Docket Item # 4
BAR CASE #2010-0295

BAR Meeting
November 3, 2010

ISSUE: Alterations (HVAC Screening)
APPLICANT: Betty and Wesley Foster by Robert Bentley Adams & Associates
LOCATION: 207 South Fairfax Street
ZONE: RM / Residential

Figure 3. Photos showing existing conditions, location of proposed rooftop mechanical equipment screen wall, view from South Royal Street, and existing HVAC units. The photo in the lower left shows that the first floor porch columns are not visible from South Royal Street or the park.

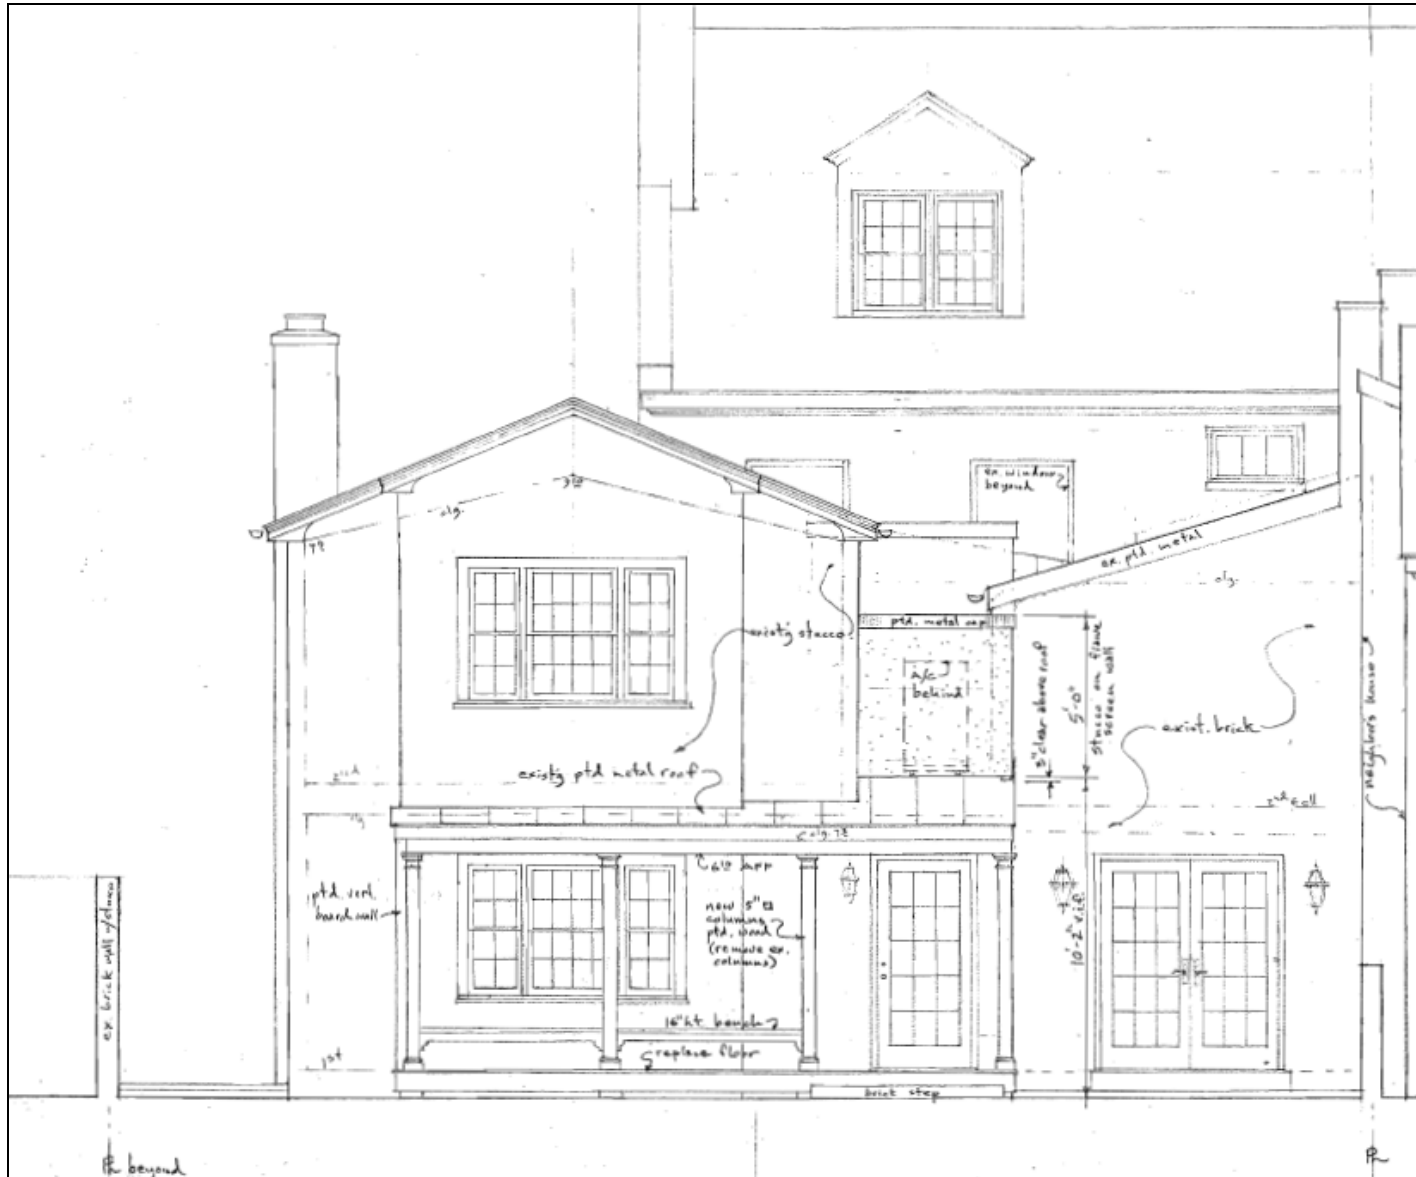
The proposed replacement of the porch columns and floor with wood columns and floor are considered historically appropriate, in-kind replacements and as demonstrated by the photo in figure #3, are not visible from a public way and do not require BAR approval.
